ERRATA SHEET FOR

CQI-9 Special Process: Heat Treat System Assessment, 3RD EDITION

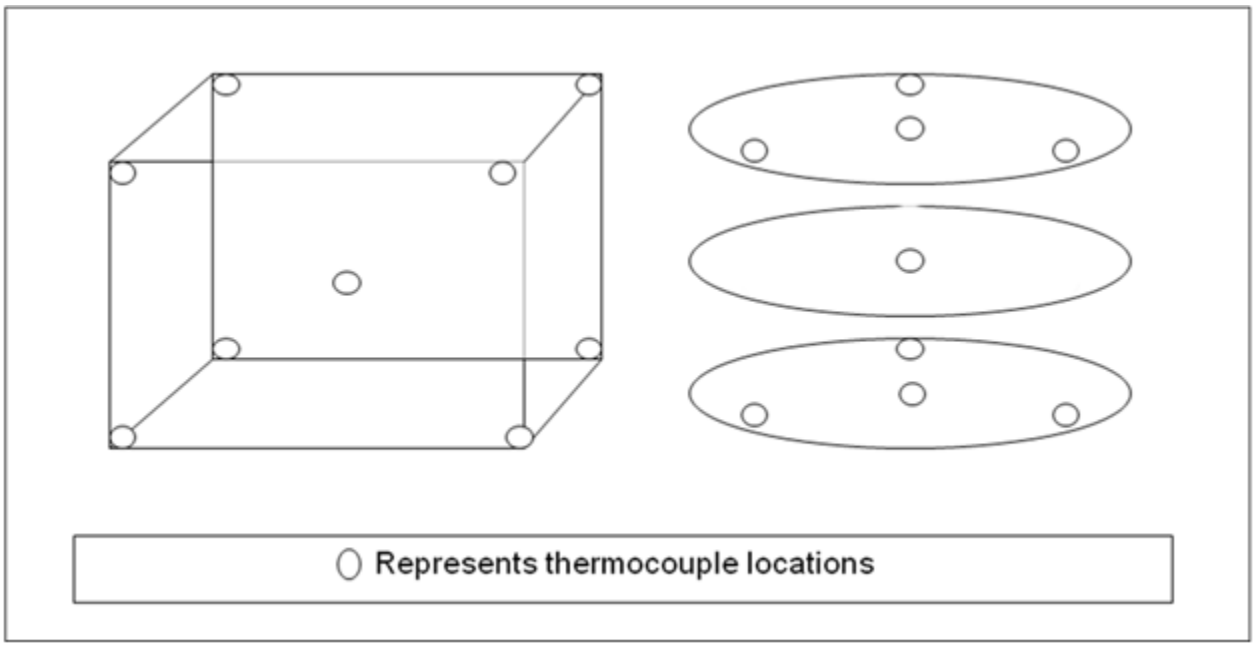
1) Figure 3.4.1 -- The 12 thermocouple locations in the cylindrical furnace is changed to 9 thermocouple locations as shown below.

ILLUSTRATION 3.3.1

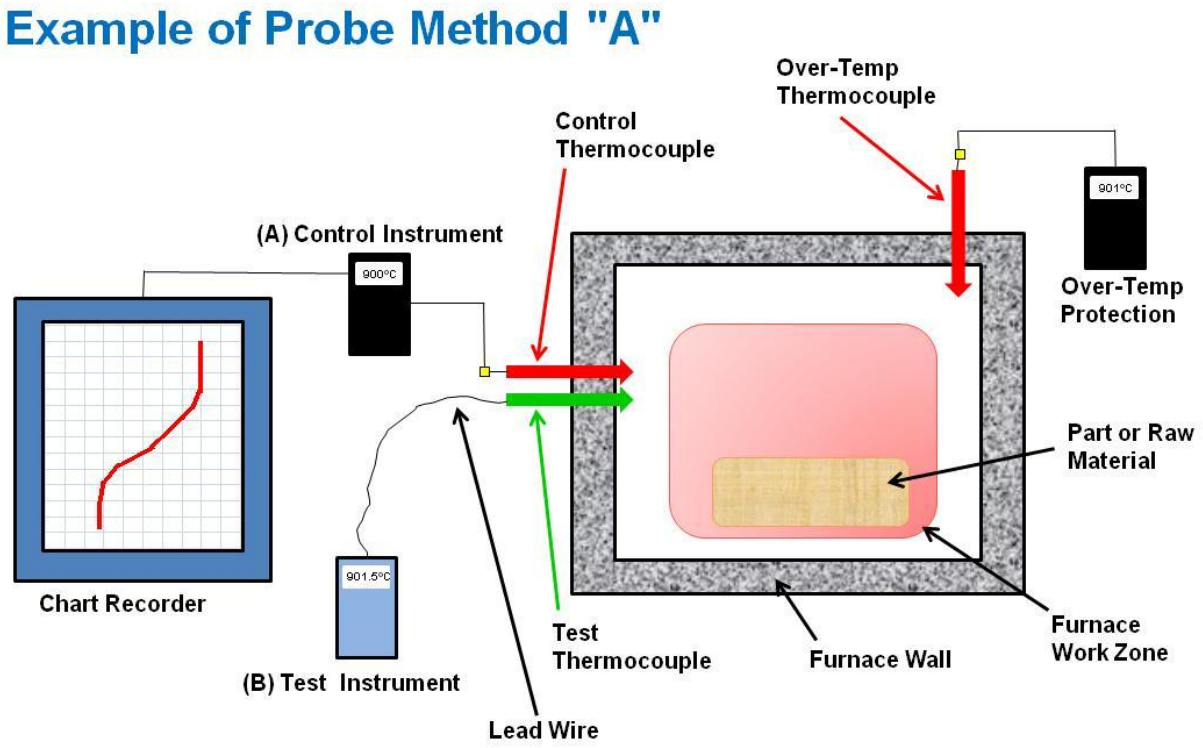
9) Illustrations 3.3.1 (page 50), 3.3.2 (page 52), and 3.3.3 (page 54) were not labeled. The temperatures in the graphics did not match the temperature values in the Example. These corrections are show below.
